# Wisconsin Department of Transportation

**Proposal #14: 1020-01-80, WISC 2022372**  
**Hudson – Baldwin**  
**IH 94 SWEF 61 Hudson**  
**IH 94**  
**St. Croix County**

This is Addendum No. 02, which provides for the following:

**ADDENDUM NO. 02**  
**PROJECT ID 1020-01-80**  
**August 4, 2022**

**Addendum No. 02**  
**ID 1020-01-80**  
**Revised Sheet 356**  
**August 4, 2022**

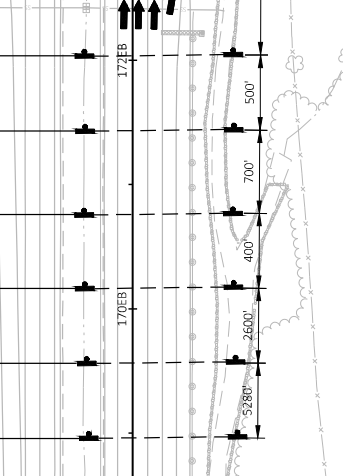
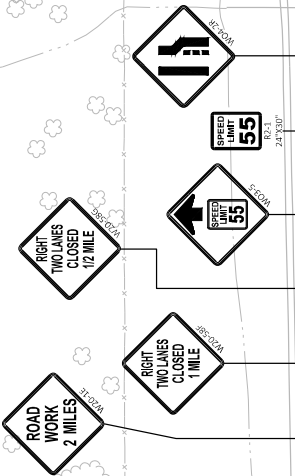
- MILL 1" EB IH 94 OUTSIDE (RIGHT) SHOULDER
- PLACE 1" OVERLAY ON EB IH 94 OUTSIDE (RIGHT) SHOULDER

- CLOSE OUTSIDE LANE AND SHIFT TRAFFIC TO MEDIAN LANE DURING NIGHT/OFF-PEAK HOURS AS SPECIFIED IN THE CONTRACT SPECIAL PROVISIONS.
